**Work Order ID 84918**

Item Name: Skidtube RH

# **DART SERVICE INSTRUCTION**

TO AMEND INSTALLATION INSTRUCTIONS IIN-D209-669 REV. B

INSTALL TOW RING ASSEMBLY AS SHOWN BELOW (REFER TO SECTION F-F OF IIN-D209-669 REV. B.

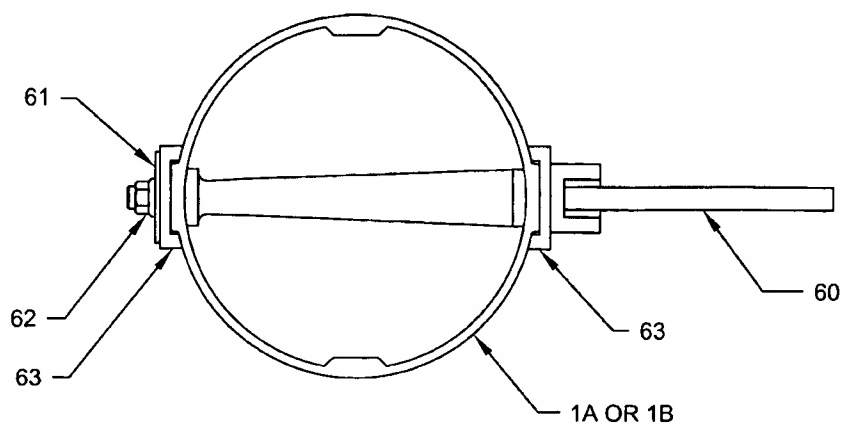
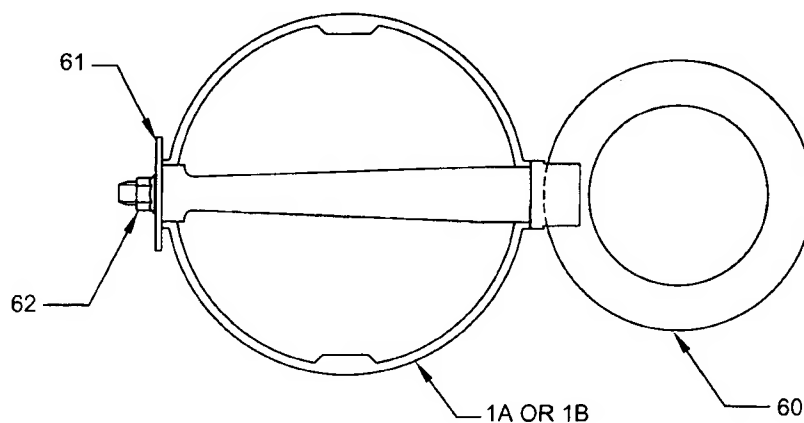
- a) REPLACE THE D2968-041 TOW RING WITH THE D3407-041 TOW RING ASSEMBLY.
- b) REPLACE THE D2736-1 AND D2736-3 GHW LUGS WITH THE D3405-041 AND D3405-043 LUG ASSEMBLIES.
- c) AMEND THE PARTS LIST IN SECTION 5.0 OF INSTALLATION INSTRUCTIONS IIN-D209-669 REV. B AS SHOWN ON PAGE 2 OF THIS DSI.

IS:

WAS:
